**Anchor QEA Memorandum
“Response to U.S. Army Corp of Engineers’ Request
for Additional Information”**

To: Erin Legge, U.S. Army Corps of Engineers **Date:** March 28, 2013
From: Heather Griffin, City of Everett
Heather Page, Anchor QEA, LLC
Re: Kimberly Clark DWO Project (NWS-2000-34)
Response to U.S. Army Corps of Engineers' Request for Additional Information

Figure 3

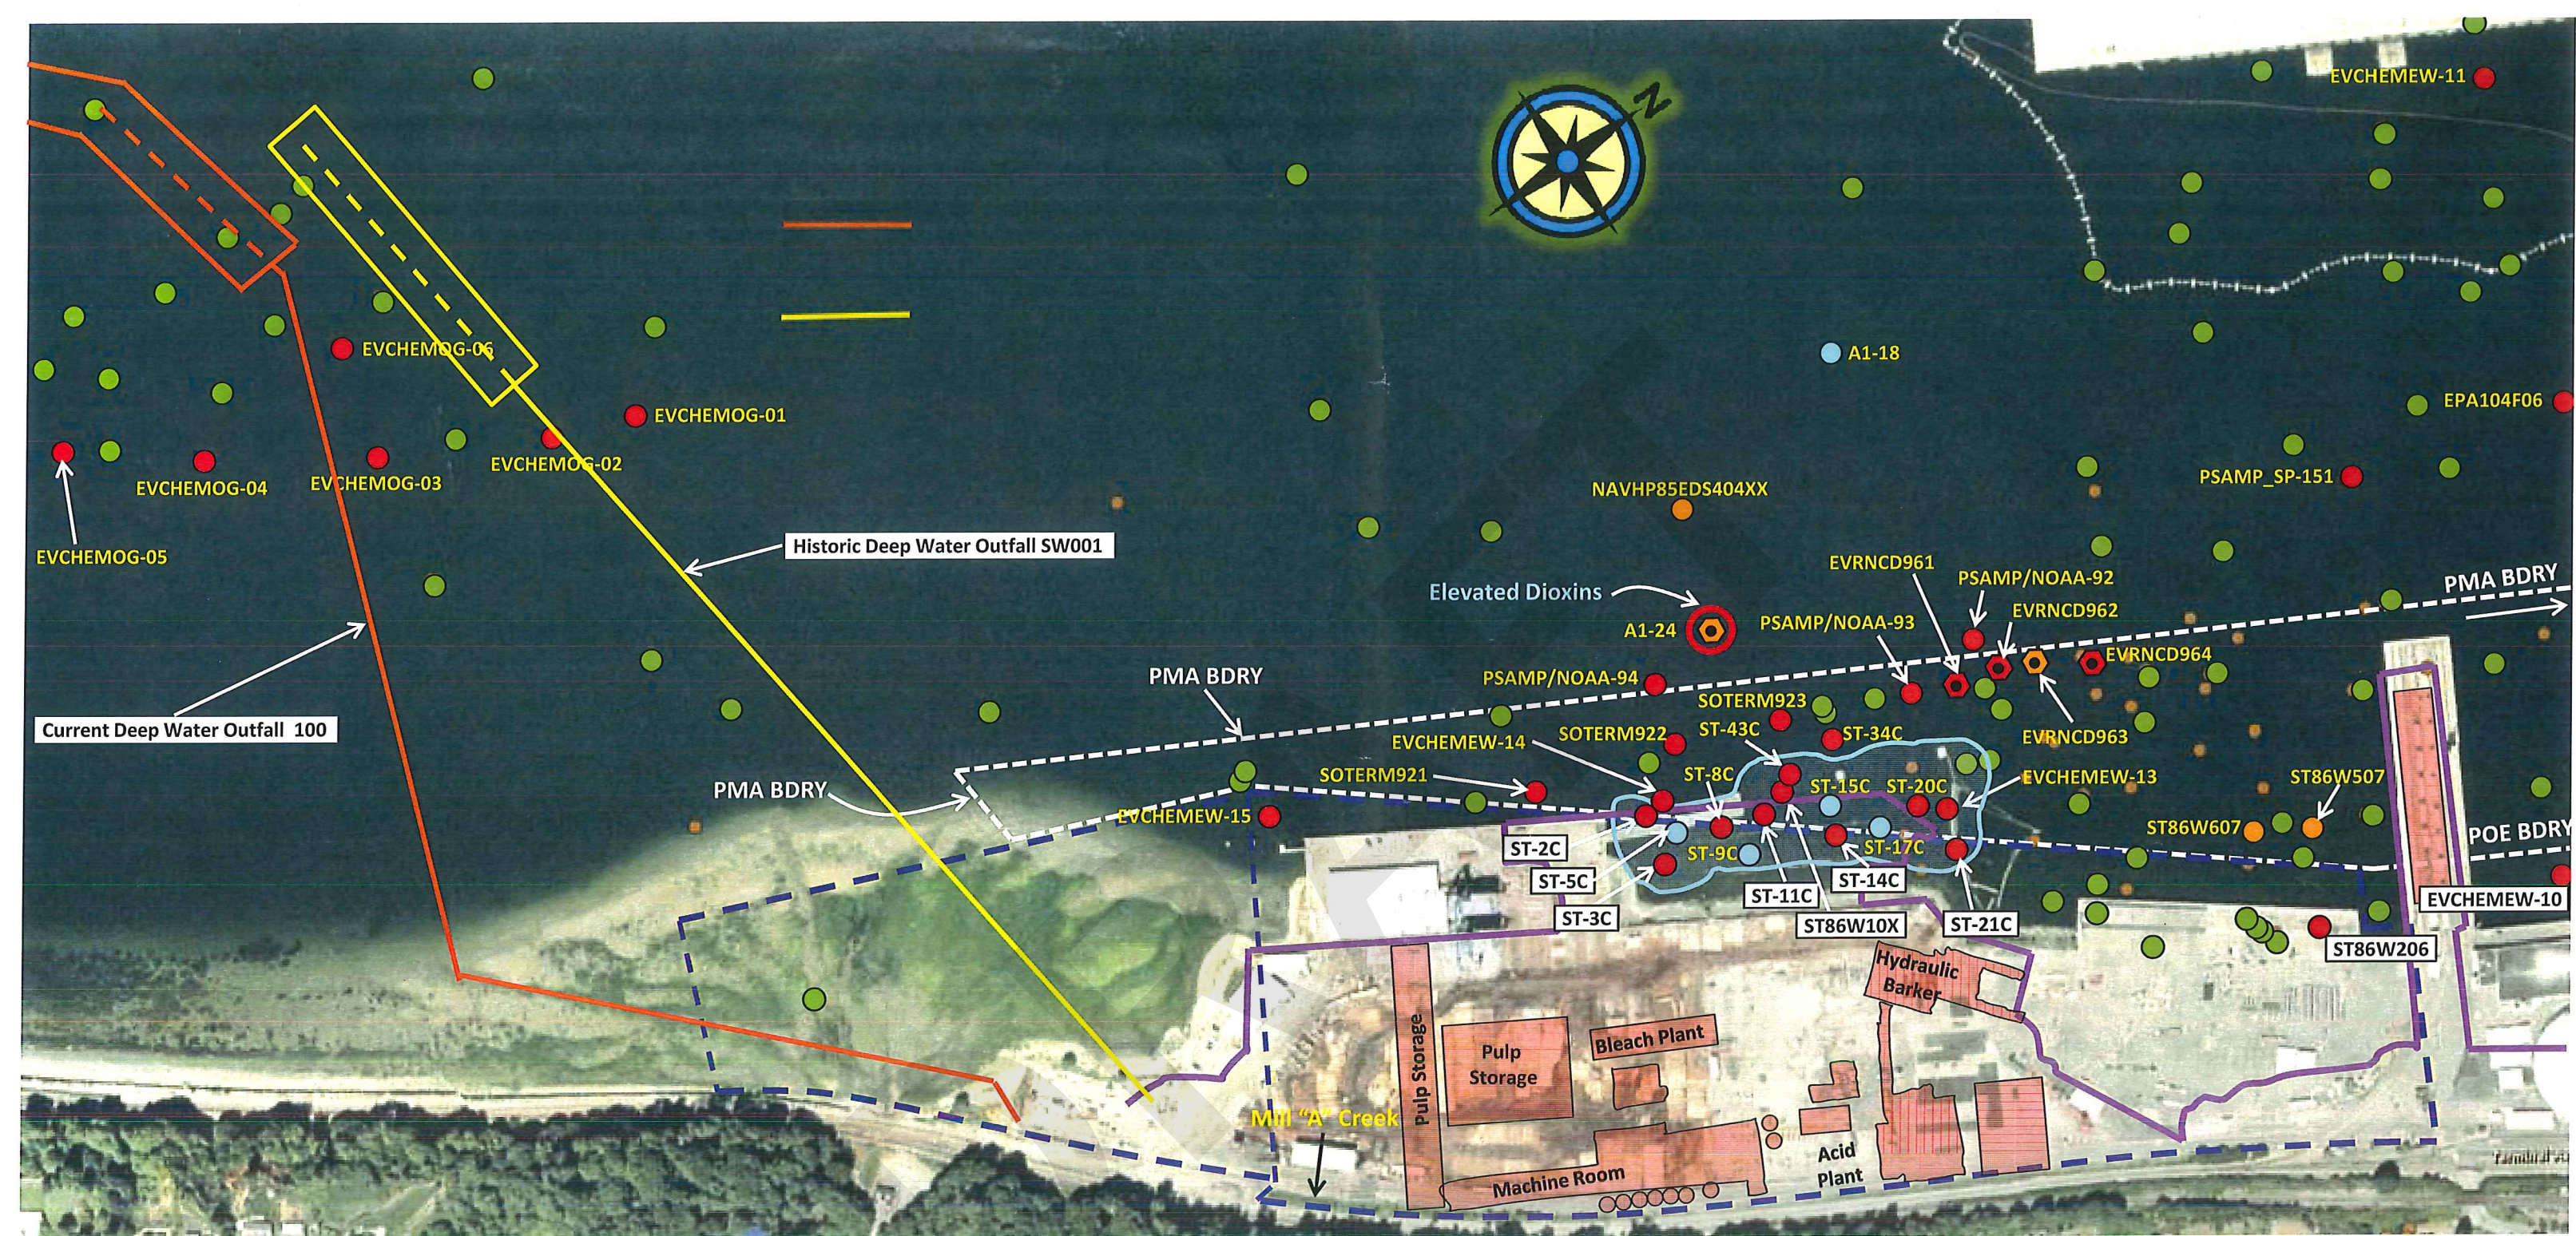
WHERE IS THE SITE IN RELATION TO A MODEL TOXICS CONTROL ACT (MTCA) CLEAN UP AREA?

As an update to the City's response in JARPA Question 9.i., the project site has no known contaminated sediment. According to the Washington State Department of Ecology (Ecology)/Port, the project is within the Weyerhaeuser Mill A Former Model Toxics Control Act (MTCA) Site, which has known sediment contamination. The nature and extent of contamination has not been defined for this Site and will be determined as part of the Remedial Investigation/Feasibility Study (RI/FS). Please note that there have been no documented exceedances of the cleanup standards within the KCDWO Project area (see figures in Attachment 3).

PLANTING PLAN

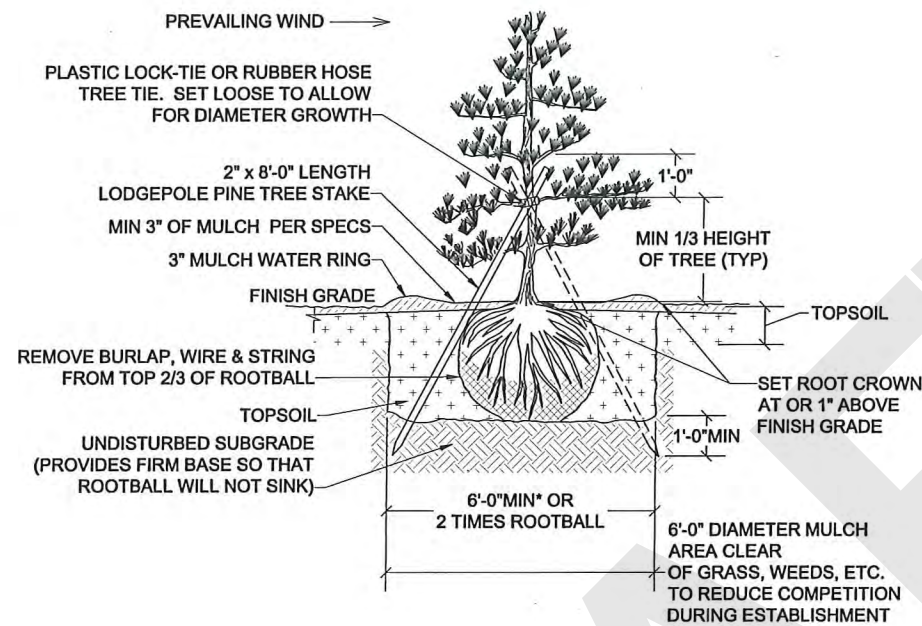
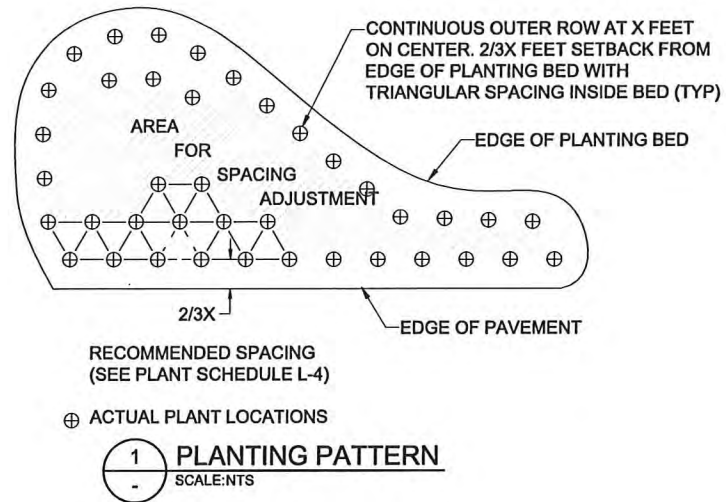
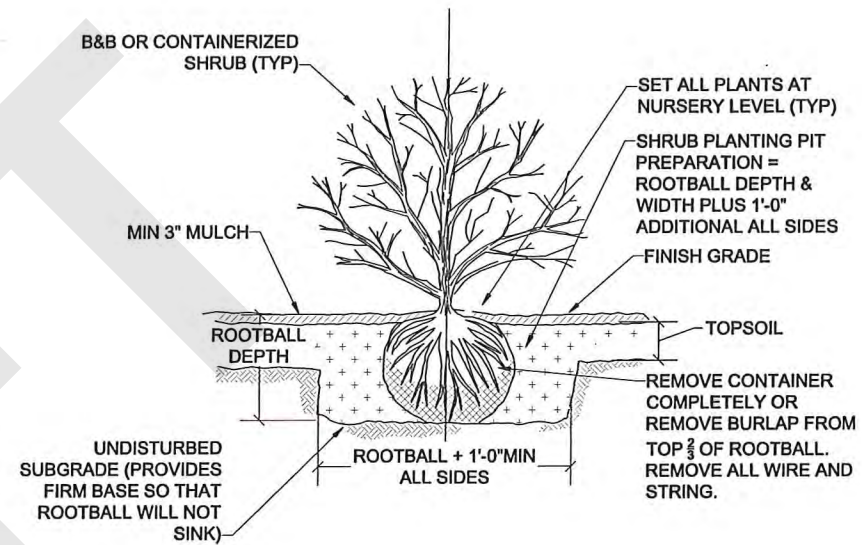
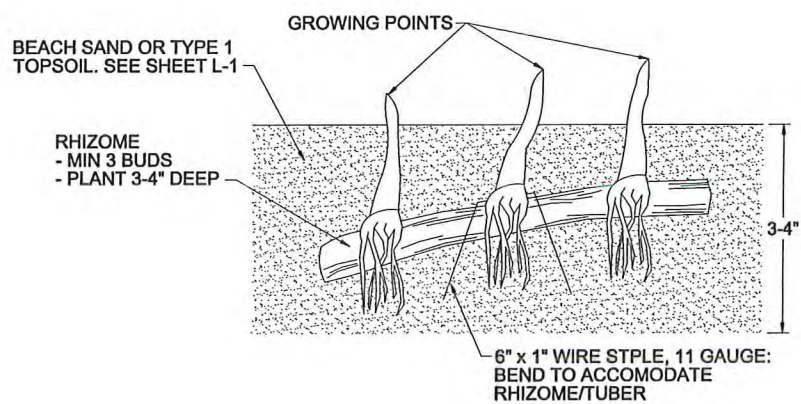
Planting plan using native riparian plant species

Please see Attachment 3 the planting plan proposed for the project.
